**UNITED STATES
NUCLEAR REGULATORY COMMISSION
REGION IV
611 RYAN PLAZA DRIVE, SUITE 400
ARLINGTON, TEXAS 76011-4005**

**SUBJECT: CALLAWAY PLANT - NRC INTEGRATED INSPECTION
REPORT 05000483/2006003**

Docket: 50-483
License: NPF-30
Report No.: 05000483/2006003
Licensee: Union Electric Company
Facility: Callaway Plant
Location: Junction Highway CC and Highway O
Fulton, Missouri
Dates: March 25 through June 23, 2006
Inspectors: M. S. Peck, Senior Resident Inspector
D. E. Dumbacher, Resident Inspector
R. E. Lantz, Senior Emergency Preparedness Inspector
D. L. Livermore, Reactor Inspector
B. K. Tharakan, Health Physicist
Approved By: W. B. Jones, Chief, Project Branch B

Figure 1
Containment Heat Exchanger

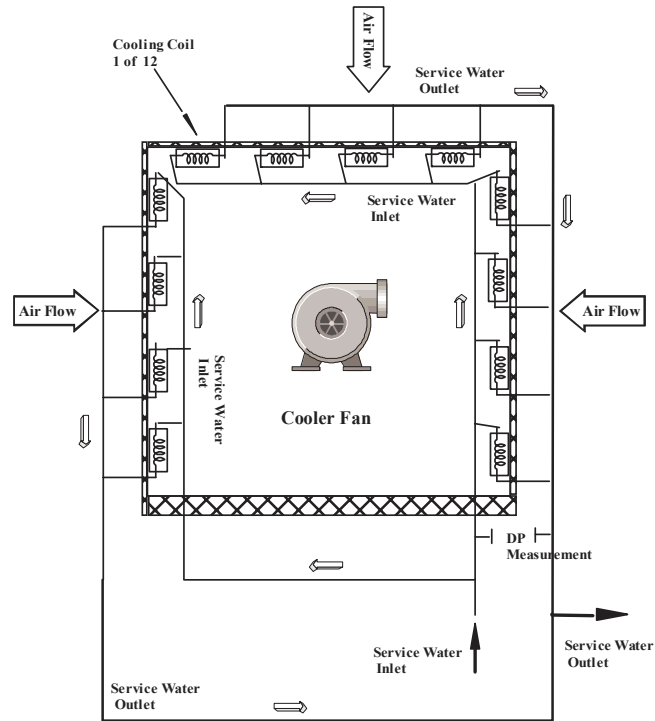
Introduction: The inspectors identified a Green noncited violation (NCV) of 10 CFR Part 50, Appendix B, Criterion XI, after AmerenUE failed to perform adequate postmodification testing of the containment heat exchangers. The inspectors identified examples of postmodification tests that did not meet the established acceptance criteria, where acceptance criteria was not established, where testing was not performed under appropriate conditions, and test methods did not meet industry standards. In addition to the findings discussed in this section, the inspectors addressed a concern with the adequacy of TS required testing in Item 2 of this section.

Description: The inspectors identified that AmerenUE had not adequately demonstrated, through performance, flow and differential pressure testing, that the containment heat exchangers would perform acceptably following installation. The Callaway Plant has two containment heat exchangers in each containment cooling train. Each train is required to remove 141×10^6 British thermal units per hour (BTU/hr) under accident conditions. AmerenUE performed containment heat exchanger replacements during Refuel Outages 11 and 12. Each new containment heat exchanger consisted of 12 parallel coils, 8 coils arranged across one service water supply header, and 4 coils across a second header (Figure 1). The postmodification testing requirements, established by Testing Requirements Determination Record 00-1018, Revision A, included:

The performance test used the Temperature Effectiveness Method to verify that the new containment heat exchangers were capable of removing the required postaccident heat load. The flow verification test used the Differential Pressure Method to verify the service water tube side was free of flow obstructions. The in-service test verified minimum service water flow was available for each containment heat exchanger. The inspectors identified that the performance test acceptance criteria was not met for two containment heat exchangers. Procedures ETP-GN-0001A and B established a minimum of 80 percent heat transfer effectiveness. The inspectors identified that the test conditions for the other two containment heat exchanger performance tests were not appropriate. In both cases the air leaving the containment heat exchangers was warmer than the air entering the containment heat exchangers. The absence of a heat load across the containment heat exchangers invalidated the test results. AmerenUE

The inspectors identified that AmerenUE failed to establish acceptance criteria for the flow verification test. The flow verification test used the Differential Pressure Method to verify no tube side flow obstructions existed for the new heat exchangers. Plant engineers measured the pressure drop across the header that supplied 8 of the 12 coils. Figure 1 indicates the location where AmerenUE measured differential pressure. The measurement was performed at the same static head on all four new containment heat exchangers. The pressure drop test results, corrected for flow variances, ranged from 20 pounds per square inch differential (psid) to 31.4 psid. The expected value from the manufacturer was 14.5 psid. AmerenUE did not perform an evaluation to address why the test results varied between the newly installed coils or from the manufacturer's expected value. The inspectors identified that AmerenUE did not include differential pressure acceptance criteria into the postmodification test. AmerenUE entered the failures to perform an evaluation of the flow verification test results and provide test acceptance criteria into the corrective action program as CAR 200600012.
